Planning Permit Officer Report

PA2302682: 23-35 Bellerine Street, GEELONG

Planning Permit Officer Report
Development Approvals & Design

Figure 12: Preferred Building Heights

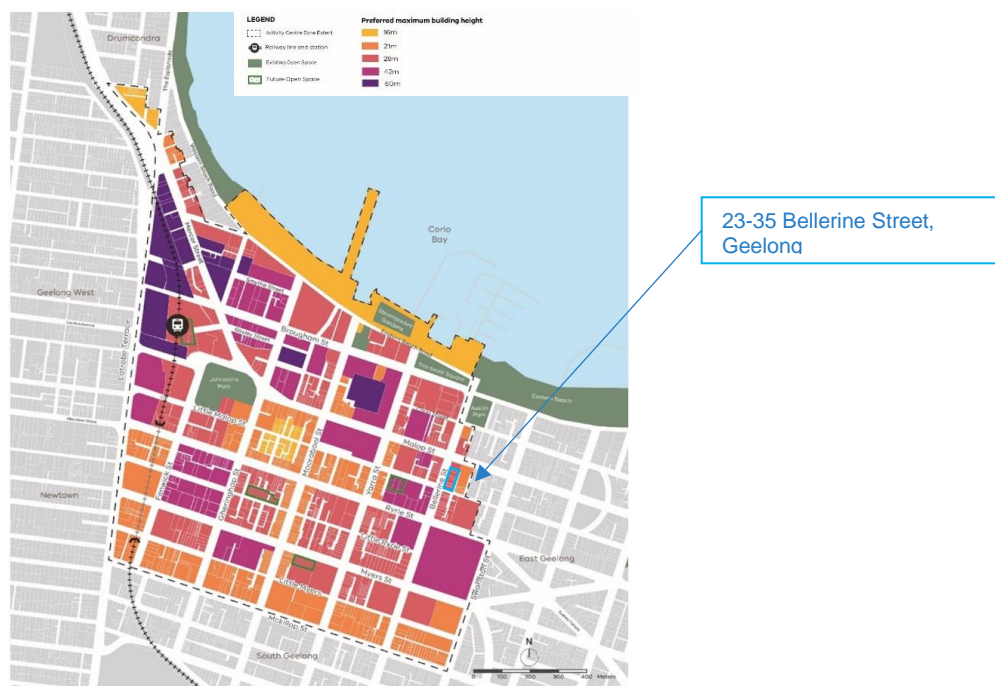
47. The proposed maximum building height of the development will be 37.8m or 41.20m AHD including services, which is slightly taller (9.8m (excluding services)) than the preferred building height of 28 metres in the precinct guidelines as defined in Map 2 to the ACZ1 (see Figure 12).

48. The controls allow for the consideration of taller built form on larger sites or where sites may have been consolidated. The planning unit under assessment includes the consolidation of a number of finer grain sites which the preferred height control intends to moderate.

49. In addition to the consideration of the consolidated planning unit, the development is similar in height to the 13 levels (40.7m) built form approved for 20-22 Bellerine Street and other developments located further north along Bellerine and Corio Streets (approved or constructed). Accordingly, this proposed development at the height proposed is considered acceptable.

Figure 14: Staggered tower setbacks of the development

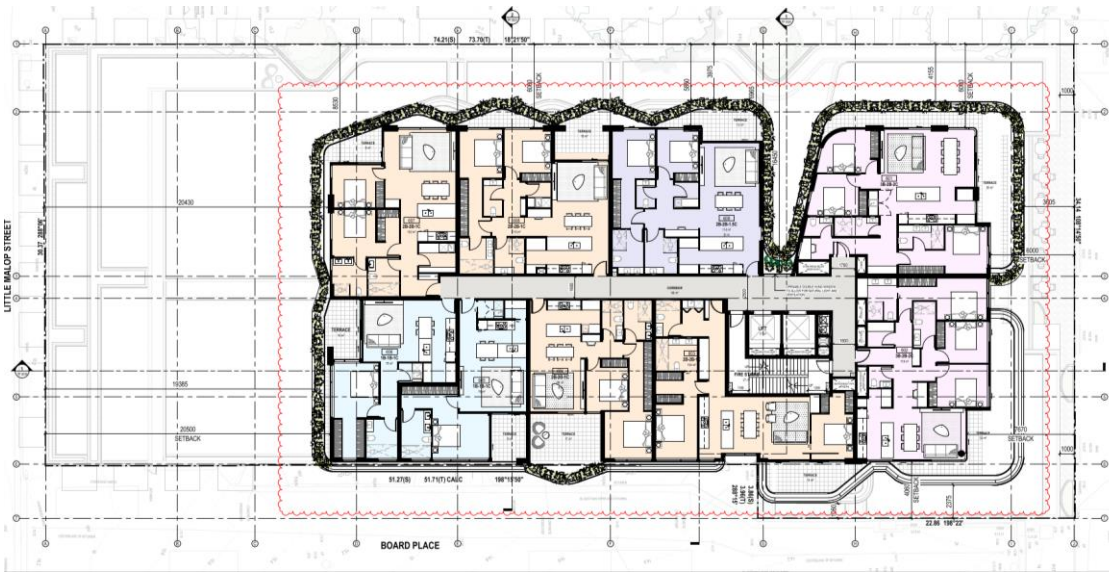
55. The controls envisage the tower to be setback a minimum 6m from Bellerine Street and all other boundaries (side and rear), as the building has a height greater than 28m and less than 42m. The proposal provides staggered setbacks as follows:
 - West (Bellerine Street) : 6m (with the balconies protruding within the setback)
 - North: 1m to 7.67m (with the balconies protruding within the setback)
 - South (Little Malop Street): 3m to 29.25m
 - East (Board Place): 2.37m to 4.6m

56. The proposal complies with the setback required to Bellerine Street, noting that the balconies protrude up to 2m within this setback. This is acceptable as the balconies will be open in structure and will allow clear views from Bellerine Street to Corio Bay (see Figure 15)

- 61. Part of the building (balconies) from level 5 above overhang outside the property's title boundary. It will be required as a condition on any approval that the development, including terraces and other protrusions be contained within the site's title boundaries.
- 62. DTP supports the reduced setbacks along the north and east given the reasons provided above, except for the overhanging of the development over Board Place. This can be rectified as a condition on any approval that may issue.

Figure 18: Land use, activation and connections at the ground level

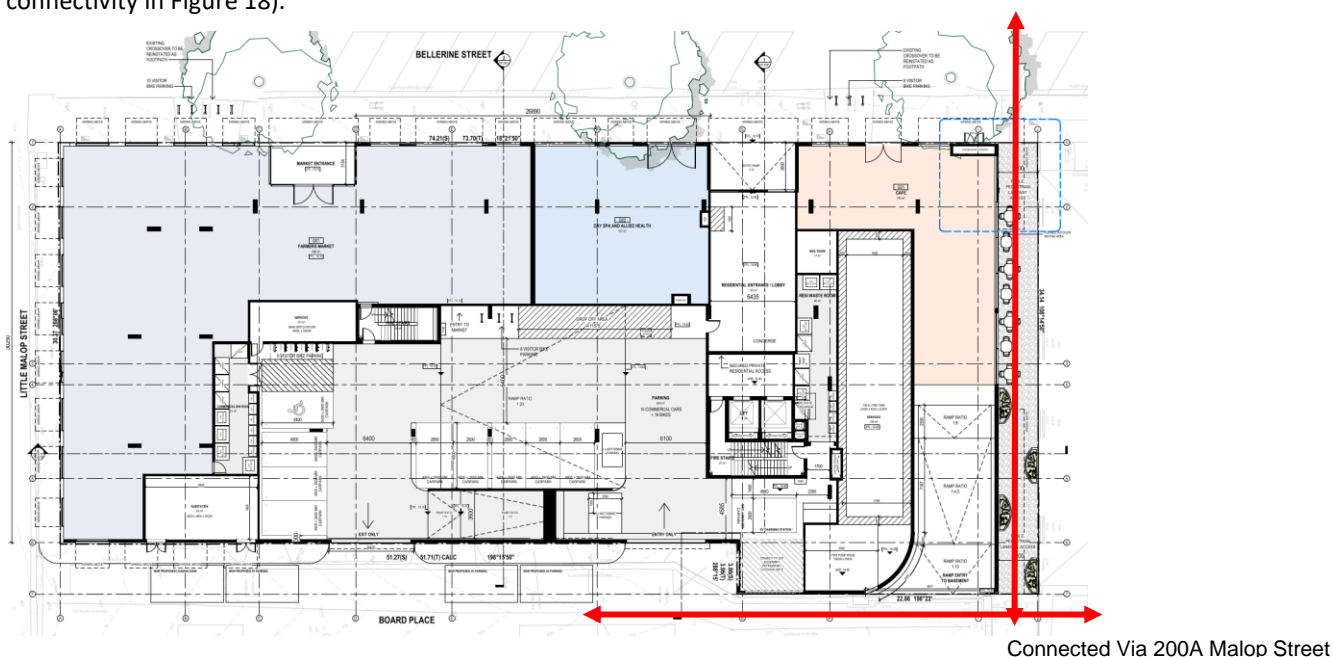
- 63. The proposal will enhance the pedestrian experience from Bellerine Street to Board Place and allow for the pedestrian connection to Malop Street by the provision of a 3m wide through block link to the north of the site (part of which will be open to sky). A café use will be largely face the block link adding vibrancy to the walkway. The through block line will allow pedestrian connections from Bellerine Street to Board Place and Malop Street via 200A Malop Street property (see connectivity in Figure 18).

Figure 21: Elevation and floor plan of Little Malop Street and floor plan of Board place

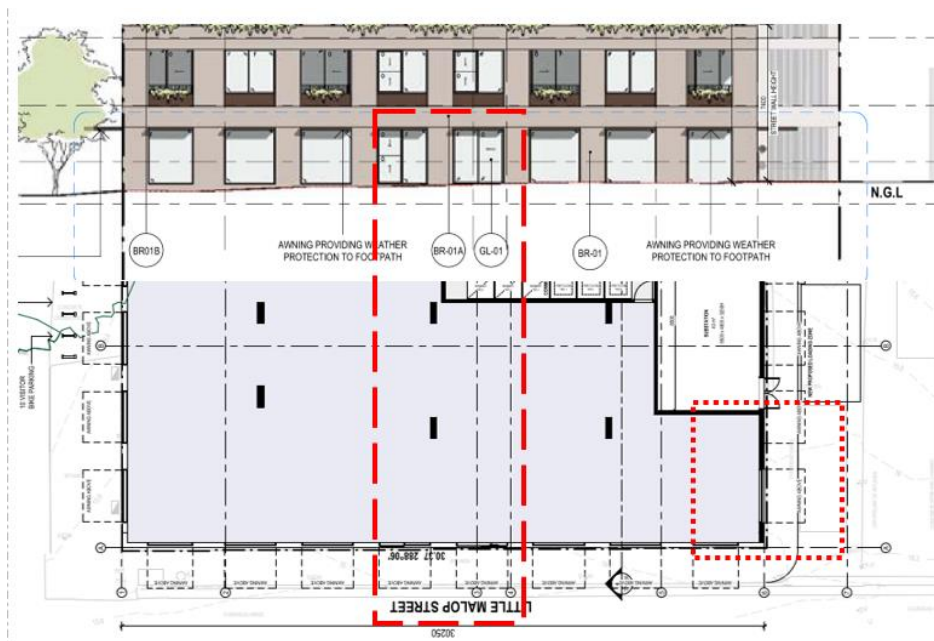
- 65. The development's ground floor response to Little Malop Street is somewhat ambiguous. The elevation drawings show provision of fixed and openable windows along this elevation (see figure 21). However, the render (Figure 20) does not show this opening as an entry given the width of the spandrels on the image. Further, the floor plans at Figure 21 do not show any steps to correspond to the height difference the renders suggest. To clarify these issues and ensure that the development has access from Little Malop Street, a condition will require that the development at the ground level is provided access from Little Malop Street.

- a. Elevation details at a scale of 1:50 (or as otherwise appropriate) illustrating typical podium details, entries and doors, detailed entrance design (given the slope on the site) building services (such as fire boosters) and how they are incorporated as part of the architecture, typical tower details, and any special features which are important to the building's presentation.

- b. Cross-sections for each commercial and retail tenancy (as appropriate) showing finished floor levels to AHD of both external and internal areas and their interface between the public and private realm demonstrating good physical and visual connection between the public realm and the interior. A range of measures such as minimal transitional areas within retail tenancies and public realm urban design outcomes (slopes and stairs etc.) can be utilised to achieve this outcome.

- c. DDA compliance from the public realm to all retail and commercial tenancies and 'private public places.
- d. Detailed internal layout plans of commercial tenancies within the podium to demonstrate active use of these internal spaces where they interface Bellerine Street, Little Malop Street and Board Place.

Figure 22: Board Street interface

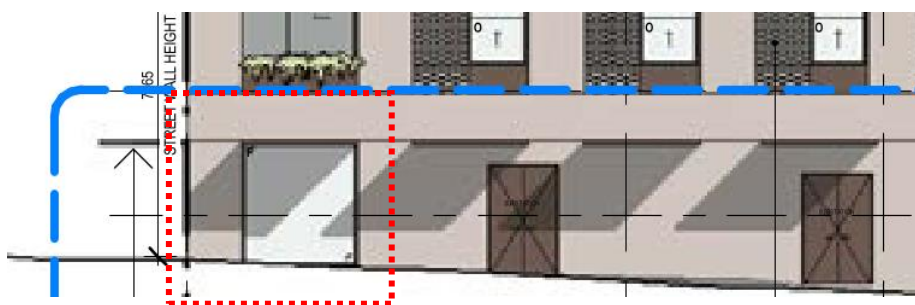
66. Similarly, with the Board Place interface, the development provides predominately services along this elevation. There is an opportunity to activate the corner of Little Malop Street and Board Place interface, which is currently a fixed window (see Figures 21 and 22). It will be required as a condition on any approval that the tenancy located at the corner of Little Malop Street and Board Place be provided with an operable façade/window or servery at the corner or with a secondary public entrance from Board Place.
67. The following conditions will also be included in any approval (façade strategy) to ensure appropriate activation of the three street interfaces through design and uses, as well as at grade entry and DDA access:

Figure 23: Overshadowing

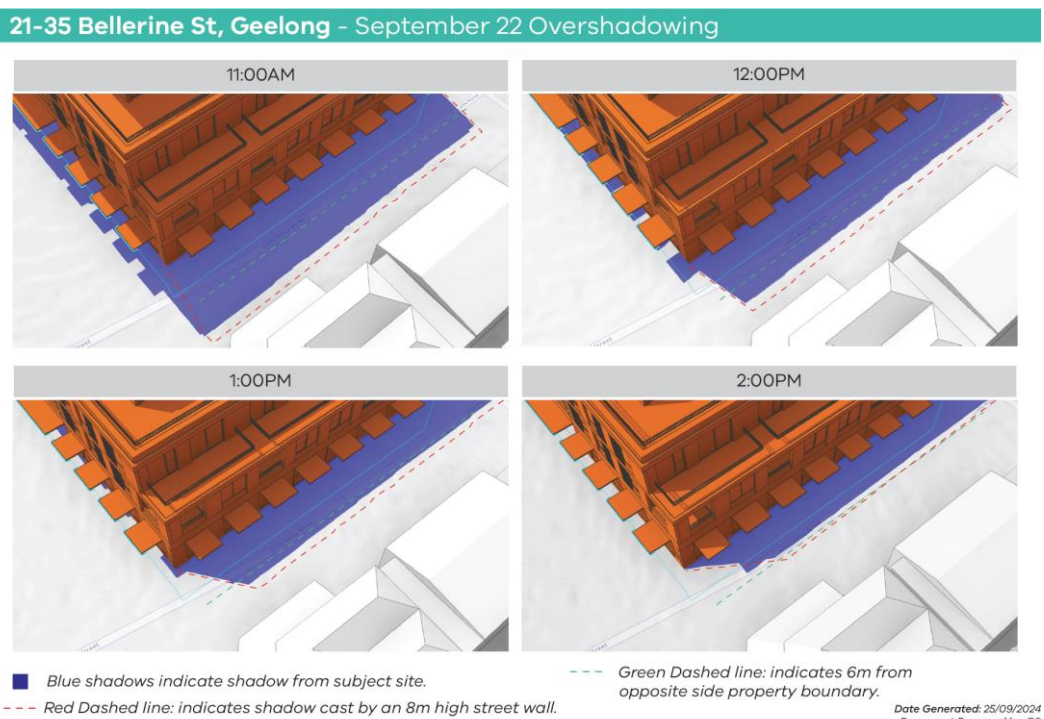
76. Overshadowing of streets and laneways: Mandatory overshadowing requirements apply to the southern side of Little Malop Street and western side of Bellerine Street. The controls at ACZ requires casts of no additional overshadowing:

- a. To a south footpath measured 6 metres from the property boundary and no additional overshadowing beyond the shadow that would be cast by a street wall height of not more than 8 metres between 11am-2pm, 22 September for Little Malop Street, and;

- b. On the opposite side of the street to either an east or west footpath measured 6 metres from the property boundary.
77. Figure 23 below demonstrates no additional overshadowing is cast by the development on the south footpath measured 6 metres from the property boundary and no additional overshadowing beyond the shadow that would be cast by a street wall height of not more than 8 metres between along Little Malop Street between 11am-2pm, 22 September. The top levels of the building have been designed to step back to avoid overshadowing of the footpath.

78. There will be no additional overshadowing concerns raised with respect to Bellerine Street (see .

Figure 24: Treatment to Bellerine Street and Little Malop Street intersection

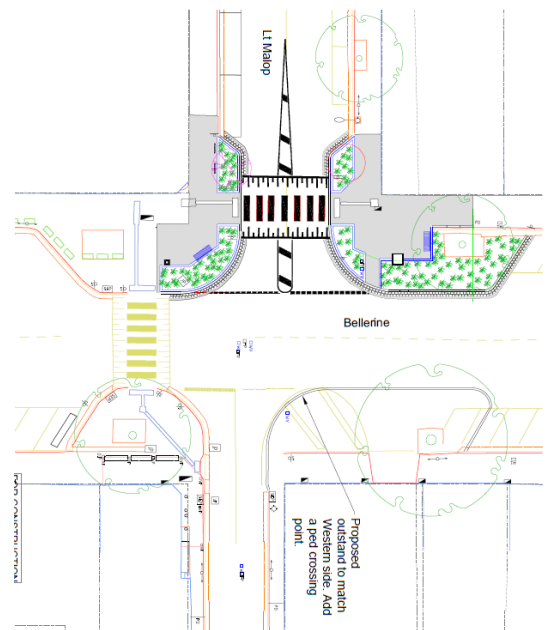
83. In lieu of the additional height that the development seeks, the development provides a 3m wide north-south, through block link to the north of the site. As shown in figure 18, the proposal will connect Bellerine Street to Board Place and allow for the pedestrian connection to Malop Street via 200A Malop Street property. This walk-way will be partially open to sky. A café use will be provided along its interface. It is expected the use will utilise the laneway, enhancing customer experience.

84. In addition, the proponent is committed to carrying out works to improve the streetscape from the property boundaries to the front of kerb along Bellerine and Little Malop Streets, and Board Place. The proponent has agreed to carry out kerb expansion/ landscaping to Little Malop/ Bellerine corner to mirror the treatment on the west side of Bellerine Street as shown in figure 24. This will be stipulated in a condition on any approval.

Figure 25: Designated loading/stopping bays

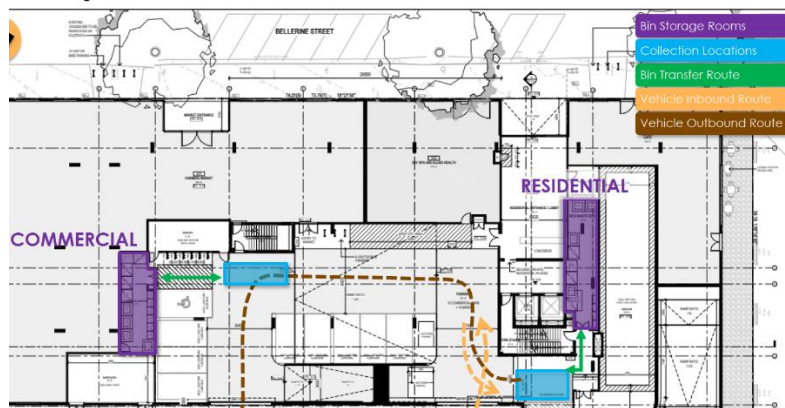
- 100. The proposal will provide a drop off zone on the ground floor. The submitted traffic report suggests that:

Given the size and use of the commercial tenancies, it is expected that the majority of deliveries will occur via small vans and utility vehicles, which can utilise the on-site drop-off area in the ground floor car park to deliver goods as required. Furthermore, an existing on-street loading area is provided along Board Place along the eastern boundary of the site, which can accommodate any loading vehicles that exceed the height restrictions within the ground floor car parking area.
- 101. The above proposition is supported. Given the overall size and capacity of each tenancy and the proposed loading/stopping area within the ground floor accessible from Board Place shown below is considered acceptable. Any loading that is required from larger vehicles can occur from the street, included existing loading areas on Board Place.
